Access Compliance Report

Public Rights-of-Way

(Curb Ramps)

Intersection ID: 50592	Main Street: BENDING_BRANCH_RD	Cross Street: BRISTLEY_RD	Location: SE
ADA ID: EC1410C16FD6	Ramp Type: Perp	Initial Pass/Fail: Pass	Overall Compliance: No
Severity Score: 5			
Codes/Mitigation Info/Possible Solution		Field Measurements/Component Compliance

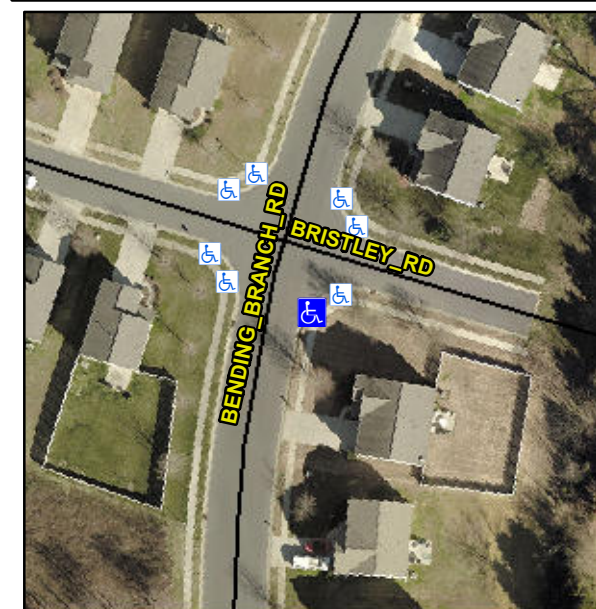
**Not Found, R304.2.2-Perp, R304.3.2-
Para, R304.5.3, R305.2, R304.5.4**

**Remove & Replace Entire Ramp.
Remove & Replace Gutter.**
